**COAL ASH IMPOUNDMENT
SITE ASSESSMENT DRAFT REPORT**

**Coffeen Power Station
Ameren Energy Generating Company
Coffeen, Illinois**

KLEINFELDER PROJECT NUMBER 112618-3

October 15, 2010

TYPICAL EMBANKMENT SECTION - RECYCLE POND

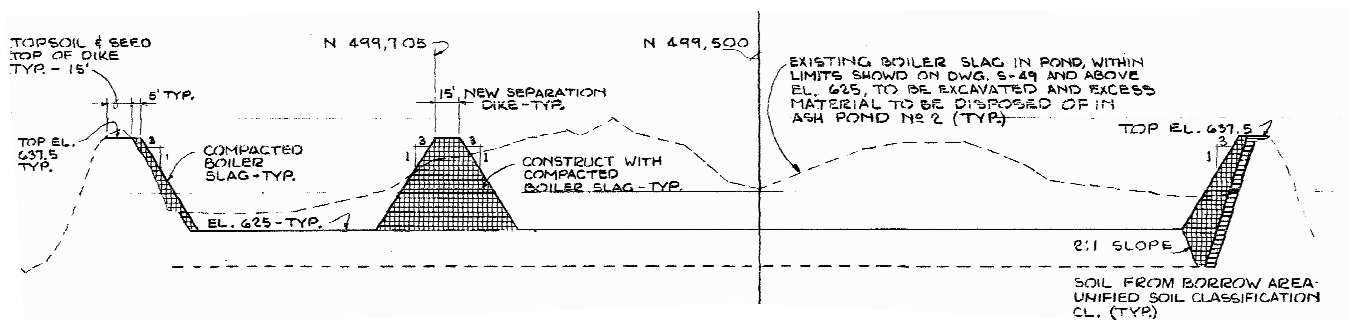
The Recycle Pond is a combination earthen embankment and incised impoundment; a typical pond cross section is presented on Figure 3. Sluice pipes transporting ash from power generating operations discharge at the west side of the pond, south of the separation dike. From the discharge point, the ash slurry flows toward the east side of the pond, north around the end of the separation dike, and then back to the northwest corner of the pond, where the pump station and overflow are located. Under normal operations water is recycled from the pond, and there is no discharge. A 24-inch emergency overflow pipe discharges into Coffeen Lake and is set at an invert elevation of 631 feet. The typical operation water surface elevation is unknown.

- The upstream slope was laid back at approximately 1.5H:1V, based on visual observations. This varies from the construction documents provided by Ameren, probably due to the build-up of bottom ash on the embankment. However, it is possible that cleanout operations at the Recycle Pond could have cut into the embankment and steepened it over time.
- Minor erosion rills, less than 6 inches deep, were noted on some of the upstream slopes.
- Grasses and woody bushes were observed on the upstream slope for the majority of the south and east embankments of the impoundment.
- Mowing/Vegetation control had not been completed on the majority of the upstream slope.
